**Rockland County Solid Waste Management Authority**

#### RFP 2021-13

#### **MECHANICAL**

SUBJECT: ADDENDUM NUMBER 4

**DESIGNED** BJZ APPROVED CAD FILE: N:\2021\21033\MEP\21033 M-103.DWG ph: 631-756-1060 fax: 631-756-1064 APPROVED SHEET SIZE: D-24x36

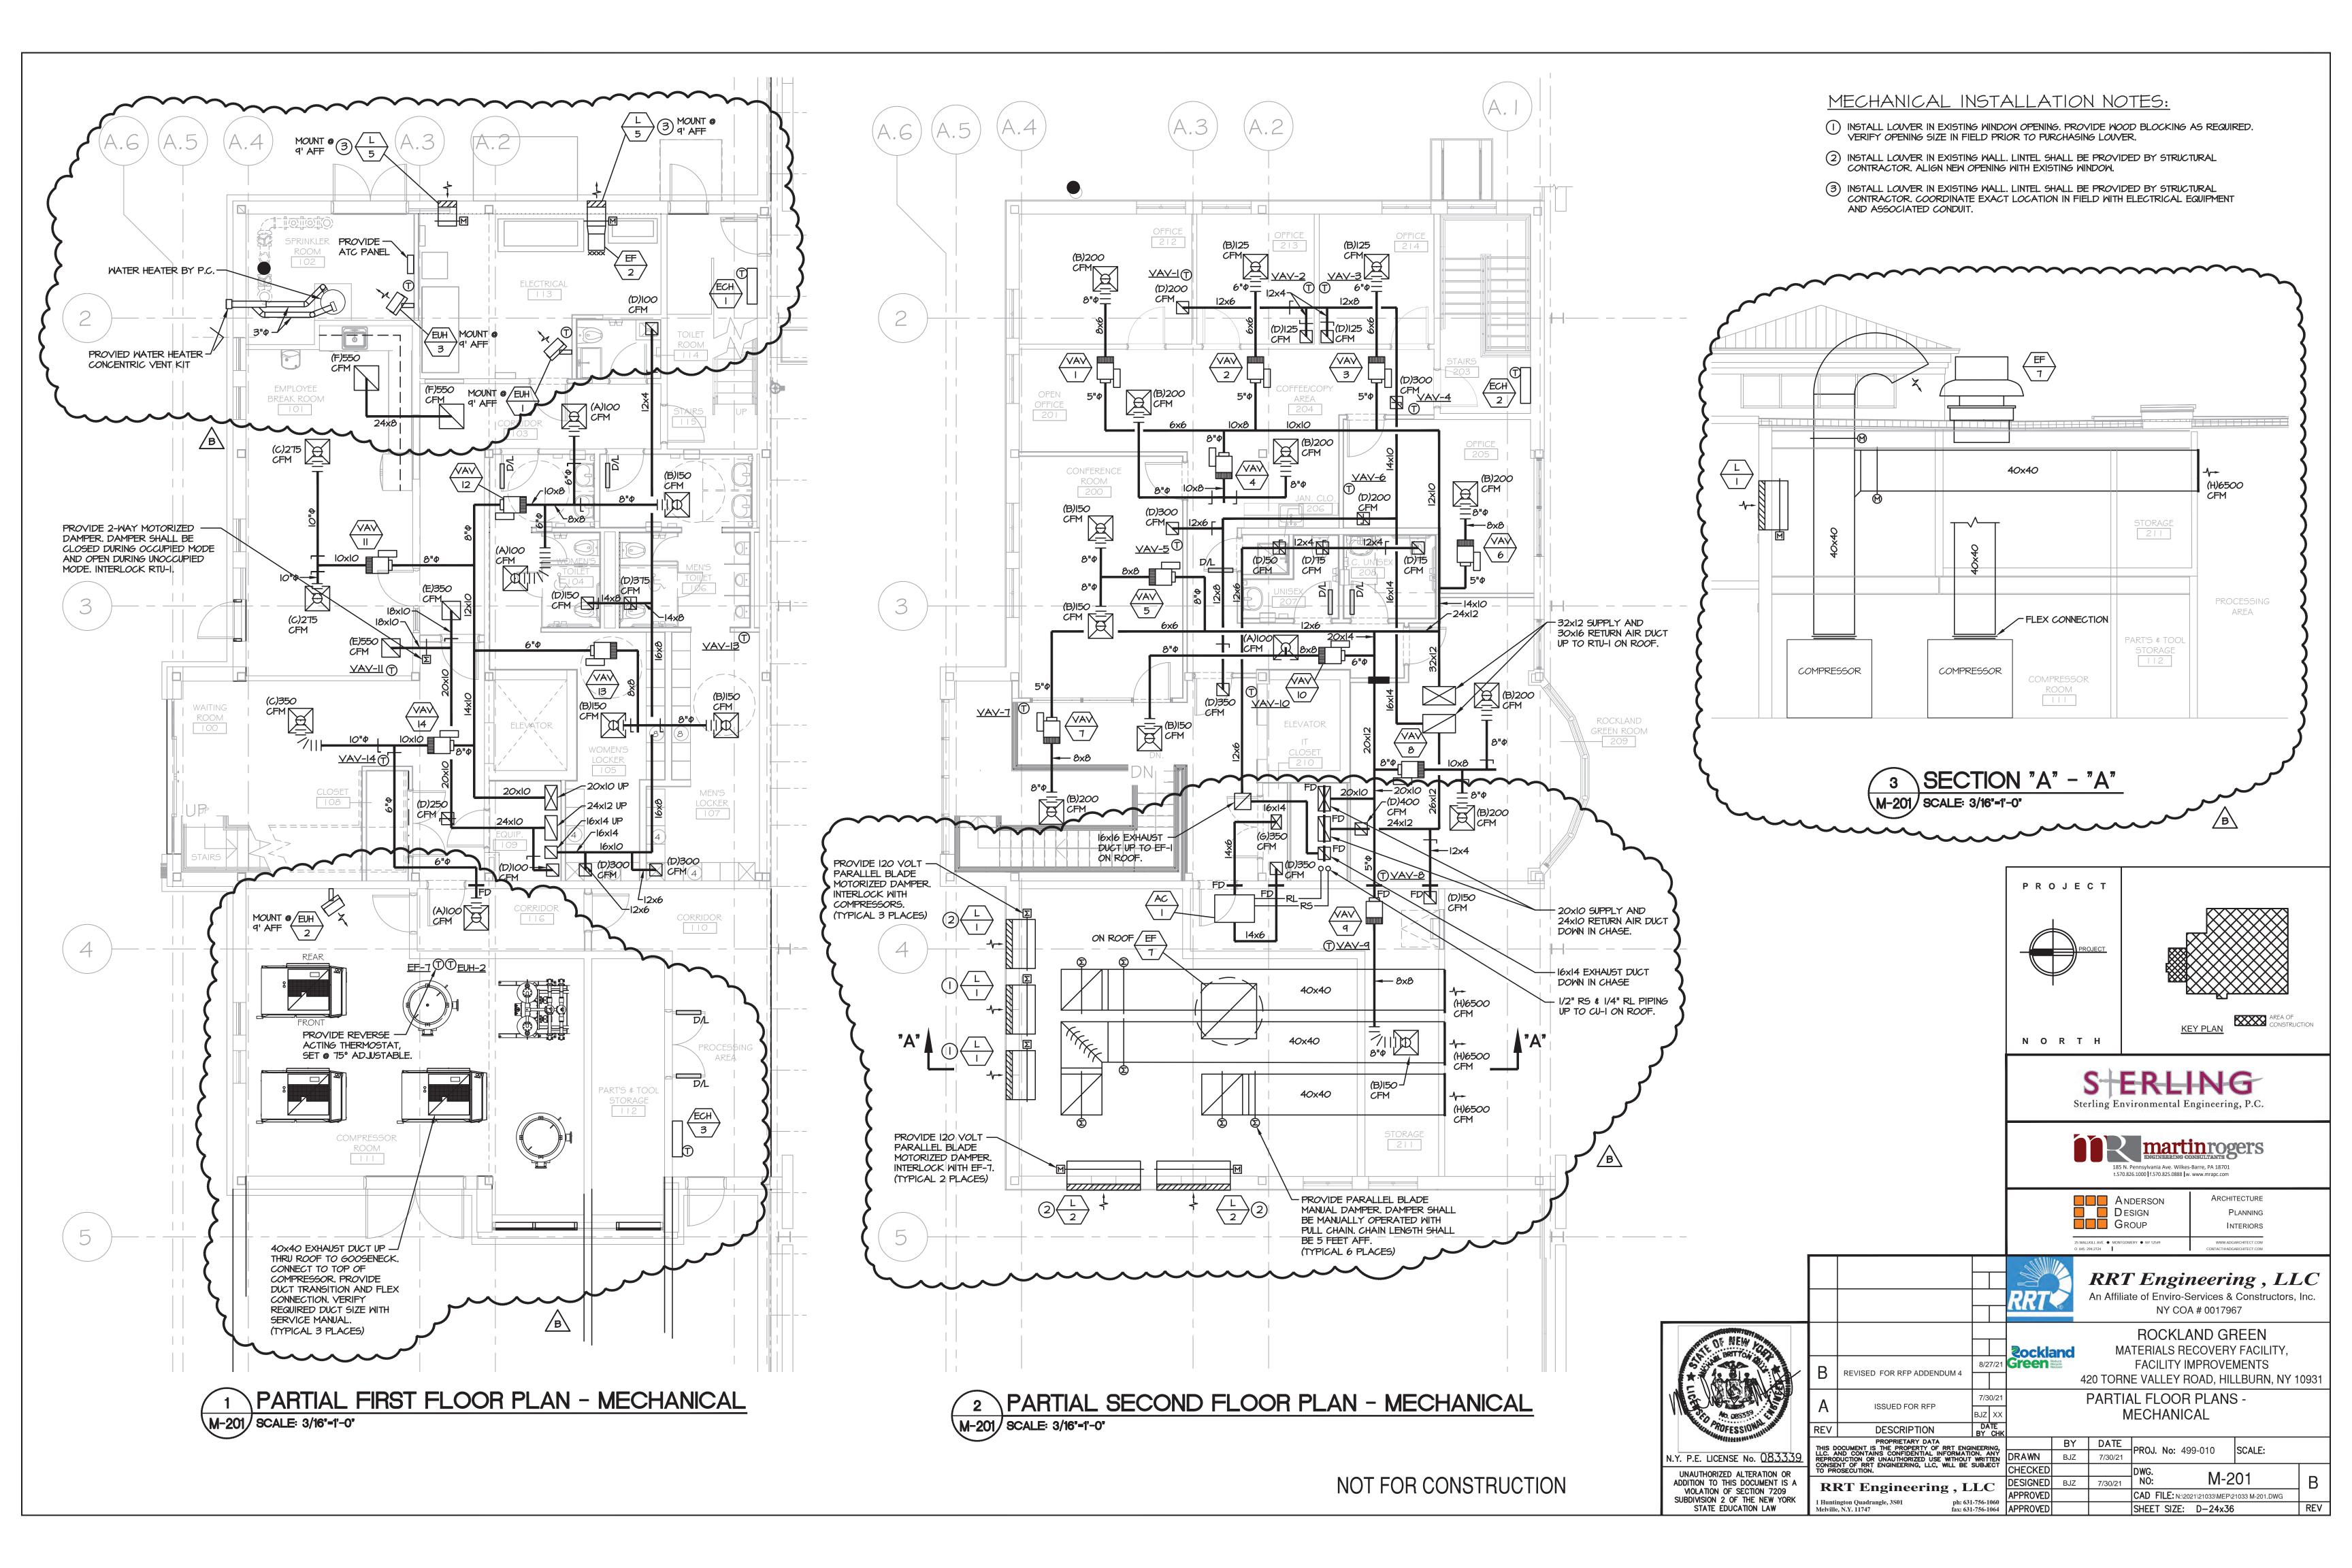
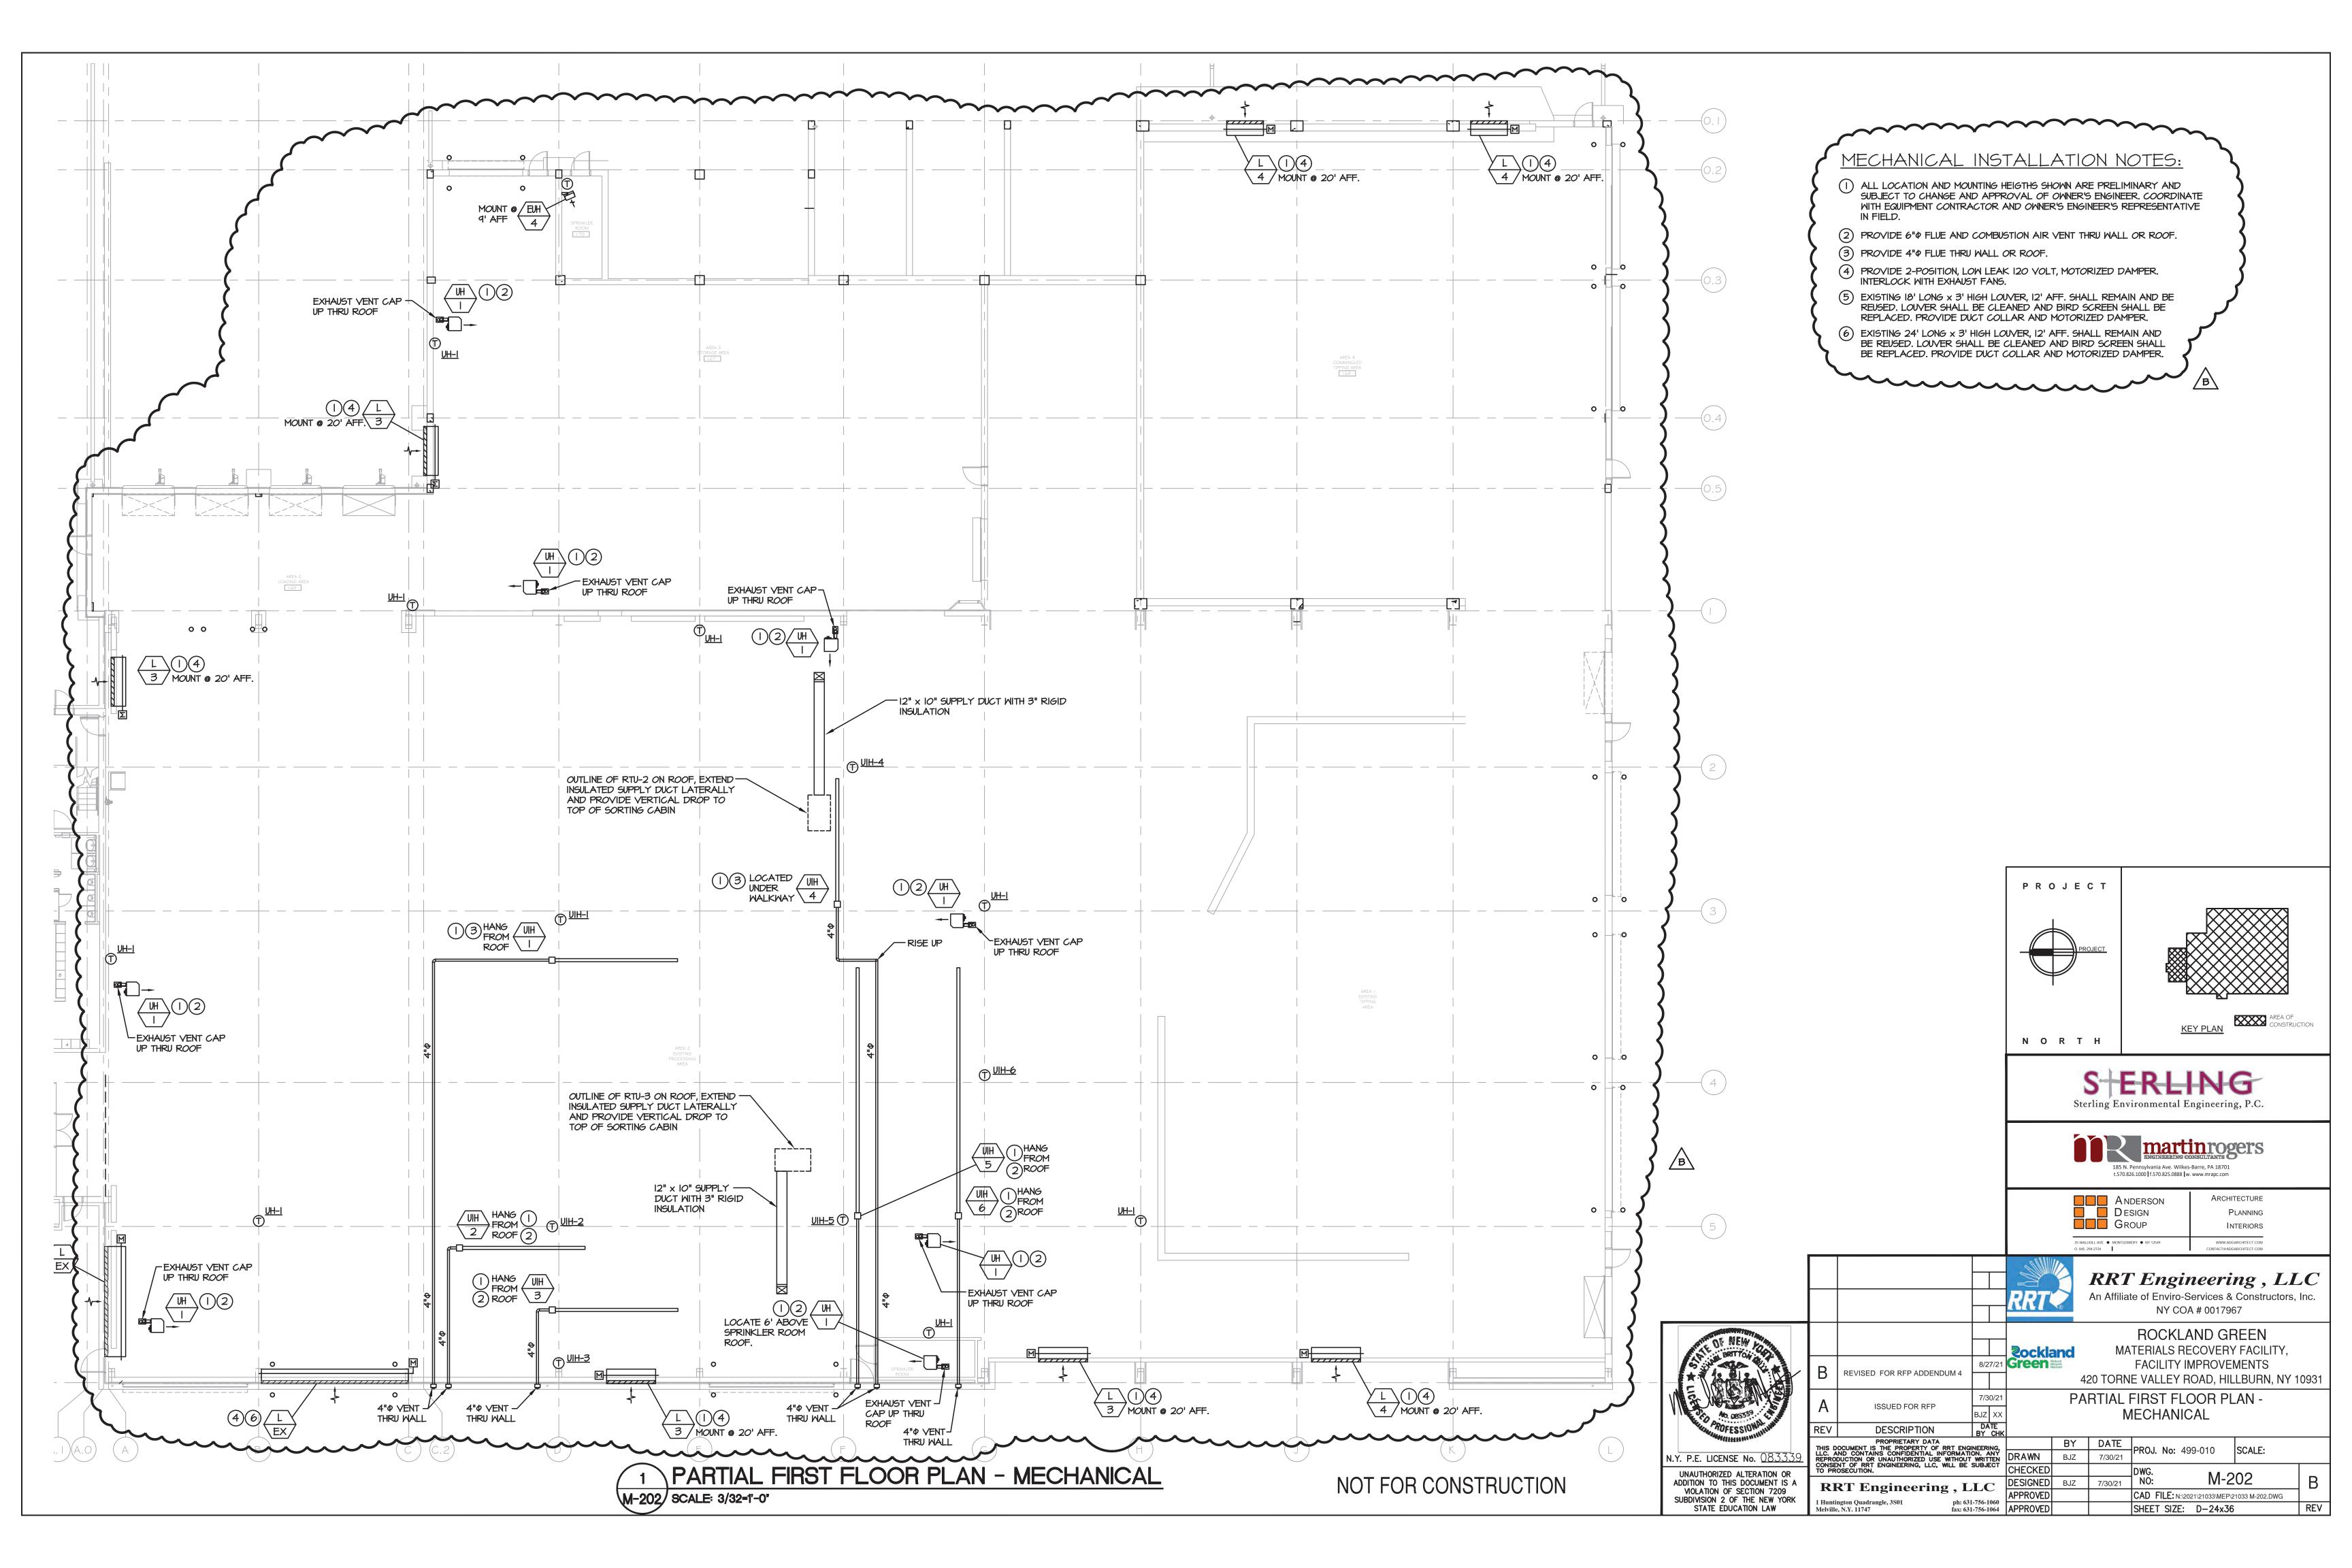
- B. Revised Demolition Notes.
- 5. Drawing M-103
  - A. Revised Demolition Notes.
- 6. Drawing M-201
  - A. Added intake louver, exhaust louver, exhaust fan and electric unit heater to Electrical 113.
